Serial: RNP-RA/02-0027

H. B. ROBINSON STEAM ELECTRIC PLANT, UNIT NO. 2
DOCKET NO. 50-261/LICENSE NO. DPR-23

REQUEST FOR TECHNICAL SPECIFICATIONS CHANGE REGARDING
SELECTIVE IMPLEMENTATION OF ALTERNATIVE RADIOLOGICAL SOURCE TERM

ANNOTATED PLOT PLAN

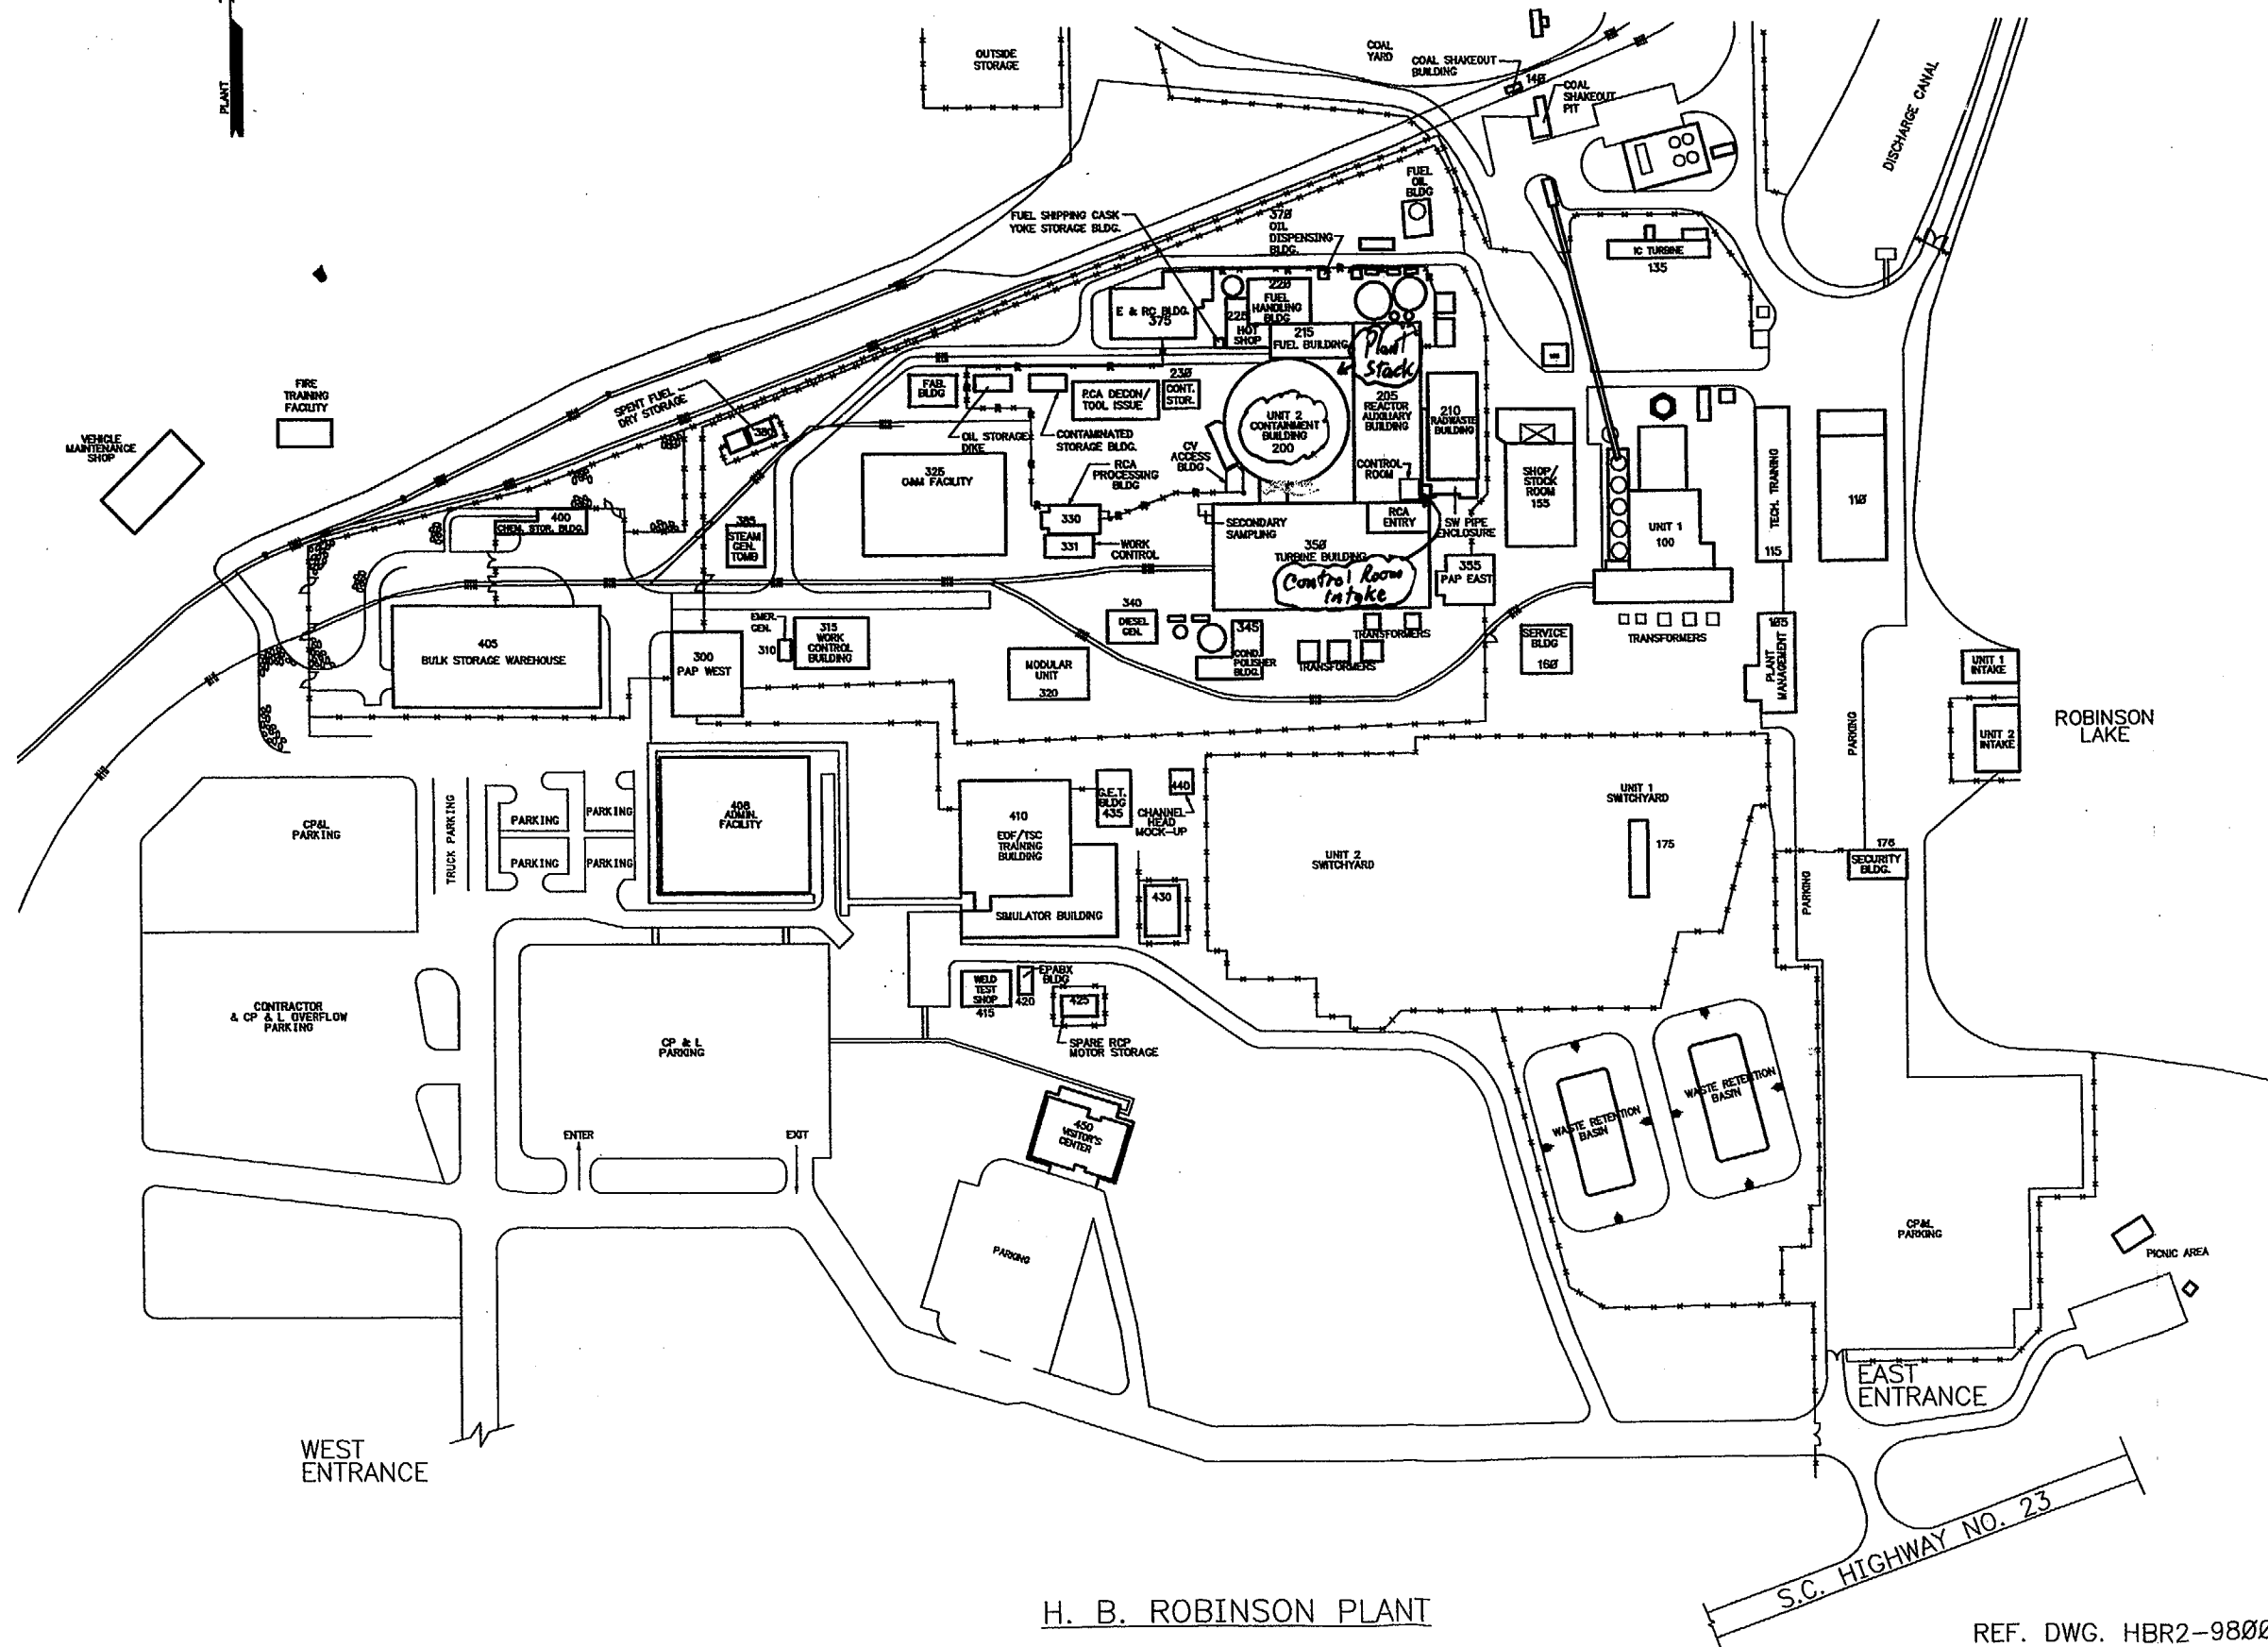
handling building is via the plant stack. Both releases are taken as ground releases. The receptor considered for each of the release points is the control room intake which is located on the east wall of the control room at elevation 250' 7" above sea level. Attachment X provides a simplified drawing showing the elevational relationships between the control room intake and the release points.

HBRSEP, Unit No. 2, is located between the 7° West and the 6° West Declination Line at approximately 6°23'. As a result, "plant north" must be adjusted to "true north" by the addition of 6.38°. The azimuthal angles for the two release points from the control room consider this adjustment from "plant north" to "true north" in the calculation of the control room λ/Q factors. The azimuthal angle from the control room intake to the plant stack is 335°, with respect to true north. The azimuthal angle from the control room intake to the containment nearest point is 313°, with respect to true north.

The actual straight-line horizontal distance to the control room intake from the containment nearest point is 116.25 feet, and from the plant stack is 157.25 feet. In the calculation of the control room λ/Q factors, these distances were reduced by five (5) feet to 111.25 feet and 152.25 feet, respectively, for conservatism and measurement uncertainty. UFSAR Figures 1.2.2-1, "Plot Plan," and 1.2.2-5, "General Arrangement Reactor Auxiliary Building Plans," have been included as Attachments XI and XII, respectively. These figures have been annotated to indicate the control room intake location, plant stack location and containment wall.
